**Our ref:** 25\_30828\_P

**Site Location:** Land off Broadgate Weston Hills  
Spalding

**Summary of Proposal:** Rural exception site  
of 24 affordable homes

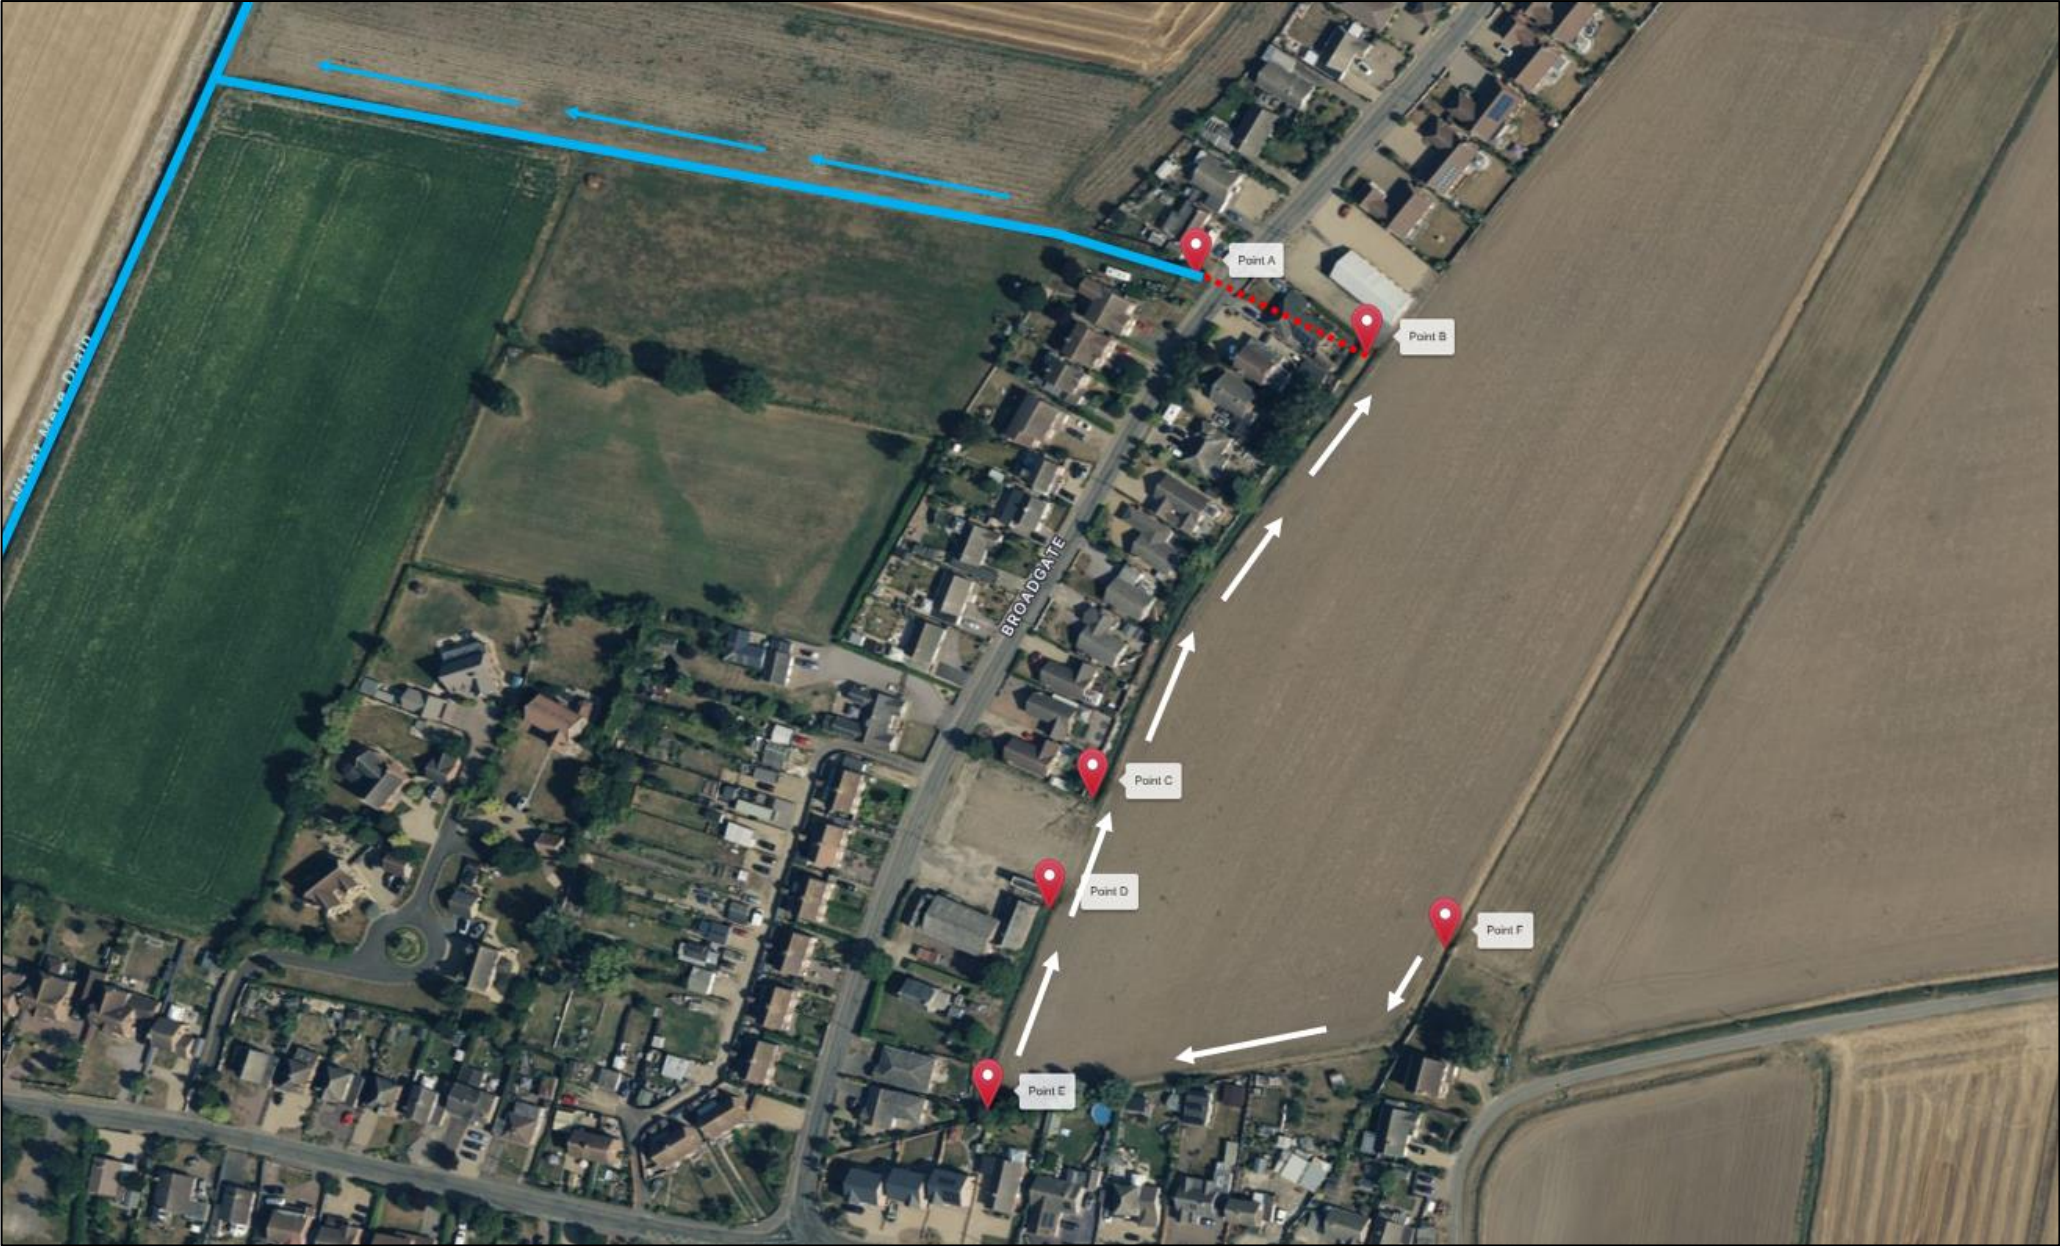
- 1) Firstly, as shown within the drawing "Drainage Strategy" ref:622-S11-00-SI-SK-C-9000, it is suggested that water within the boundary riparian watercourse surrounding the site's boundary flows anticlockwise around the site. The Board believe this to be untrue and that water within this riparian watercourse flows clockwise towards the north, as shown by the white arrows on the attached plan. Whilst water in this watercourse flows clockwise towards the north, the Board request that works to the riparian watercourse, including regrading and reprofiling works, should be undertaken to ensure that water can flow freely and efficiently.

- 2) The Board's watercourse, shown in light blue, begins at point A on the attached plan and flows westwards. A culvert not owned by the Board (shown by the red dashed line), runs under Broadgate Road, enters the riparian watercourse from the west at point B. This culvert connects this riparian watercourse to the Board arterial watercourse. Whilst we are aware of this culvert's existence, further investigative work is required by the applicant to determine the condition of this culvert to establish whether it is in a suitable condition to accommodate the additional surface water flows from the proposal.

Additionally, the Board are aware of drainage issues at this site, more specifically connectivity issues within the riparian watercourse at points C and D, under the site's proposed access road. The Board do not hold information as to whether there is a pipe connecting these two points.

We understand that the applicant is aware of these drainage issues and has subsequently created a temporary route from point E connecting to point C, due to the uncertainty of the existence of a suitable pipe. The Board request that investigative work, including a CCTV survey, is carried out to determine whether there is a pipe connecting the two ends of the watercourse at points C and D and whether it is in a suitable condition to accommodate the additional flows. Succeeding this investigative work, should it be found that this pipe is not in a suitable condition, then an appropriately sized replacement culvert should be installed between points C and D, following an application being made and Consent issued by the Board under Section 23 of Land Drainage Act 1991. The temporary route installed by the applicant can then be removed.

Until a viable discharge route into the Board's system for surface water is proved, **the Board object to this planning proposal** as we are concerned that this application may increase flood risk in the surrounding area due to the lack of a feasible connection from the site to the Board's system. The Board request further investigation and rectification works are carried out to prove that there is a viable connection between the riparian watercourses and the Board's system prior to any application being made to the Board under Byelaw 3 of the Board's Byelaws.

- 3) Lastly, the Board are deeply concerned that no regard to future maintenance of the riparian watercourse has been taken into account when designing the layout for this proposal. The proposed layout does not currently provide a maintenance strip adjacent to the watercourse and will result in the fences of 18 private gardens being installed up to the brink of the watercourse. This will lead to the watercourse having multiple riparian owners under riparian law with no suitable access to carry out their maintenance responsibilities which is likely to lead to flooding issues within the wider site and surrounding area. **The Board therefore object to this planning application** and recommends that the applicant redesigns the layout so that a suitable maintenance strip (around 3-5 metres) is left flat and free from obstruction adjacent to the riparian watercourse in order to enable maintenance by one future riparian owner/designated maintenance company/contractor.
